City of Detroit

CITY PLANNING COMMISSION
208 Coleman A. Young Municipal Center
Detroit, Michigan 48226
Phone: (313) 224-6225 Fax: (313) 224-4336
e-mail: cpc@detroitmi.gov

RE: Request of Innovo to modify the existing Planned Development zoning classification established by Ordinance No. 6-90 on Zoning Map No. 67 generally located west of the Southfield Freeway and north of the I-96 Expressway to allow for the modification of an existing greenbelt (RECOMMEND APPROVAL WITH CONDITIONS)

The more detailed landscape plan submitted for 12601 Southfield after the hearing shows the following:

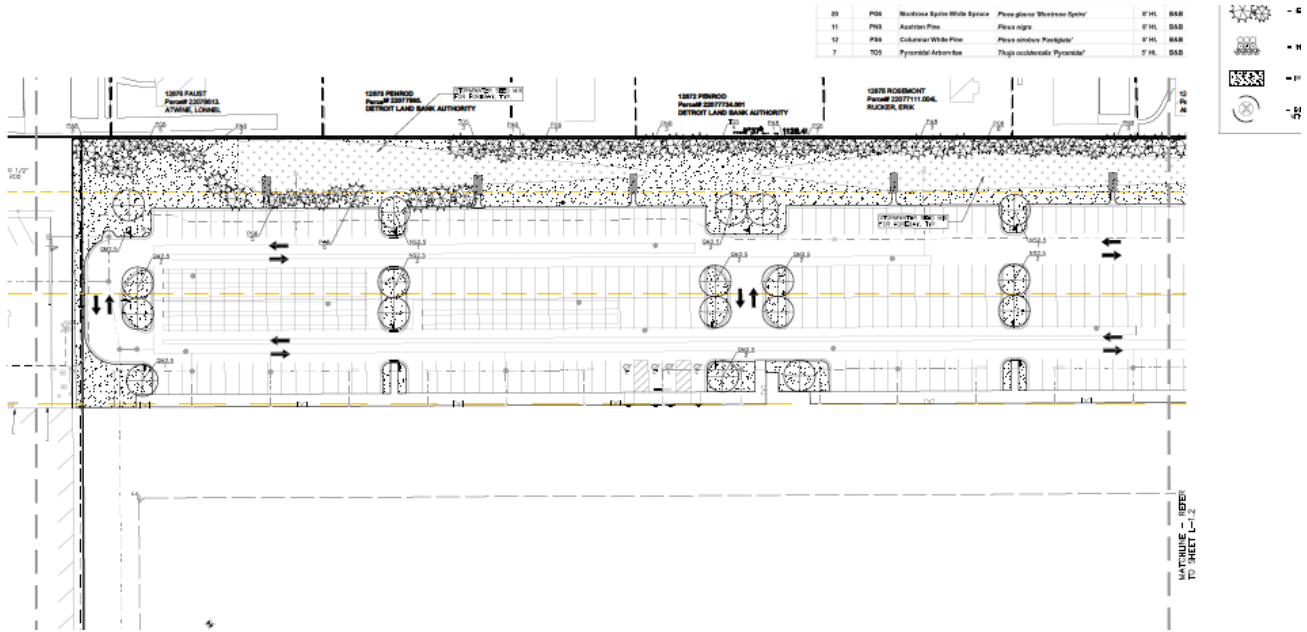
- 95 evergreen trees (including some arborvitae, in the buffer along the fence)
- 10 shrubs adjacent to the entrance from the service drive
- 5 deciduous trees (66 additional deciduous trees in the non-PD area)

- The plans look like an adequate screen planting for a parking lot that would perform year-round.
- For 12701 Southfield, the proposed planting arrangement would satisfy the screening requirement, provided they are using appropriate species to be so close. It is recommended the plan would call out the spacing directly on the plan to better verify spacing is ok based on the variety of evergreen trees being proposed.
- For 12601 Southfield, the plan should include tree spacing on the plan itself, especially when alternating species.
- Recommend additional trees be on the site where Ashton Street ends.
- Overall, the proposed landscape plan is good and will accomplish the goal. The landscape firm should confirm the spacing of the evergreens along the residential properties.

2. That the landscaping plan within the PD zoning district must include evergreen trees with the spacing 10 to 15 ft apart dependent on species, 5 ft apart for arborvitae, and additional plantings where feasible, with the final landscaping plan subject to review and approval by City Planning Commission staff; and

For 12701 Southfield, the plan submitted after the hearing shows the following:

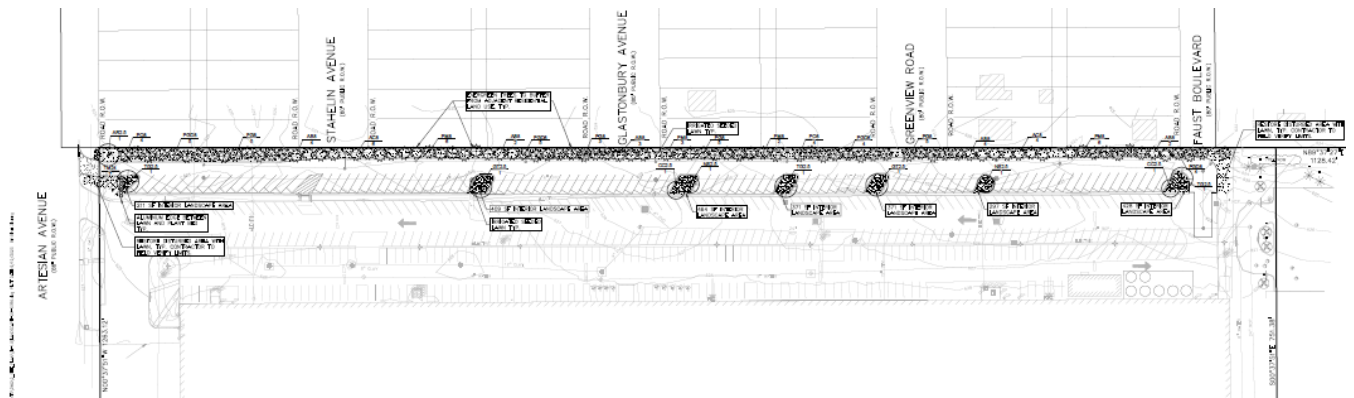
- 86 evergreen trees (no arborvitae) in the buffer along the fence
- 7 shrubs adjacent to the entrance off of Artesian St.
- 7 deciduous trees primarily in the new parking lot islands
-
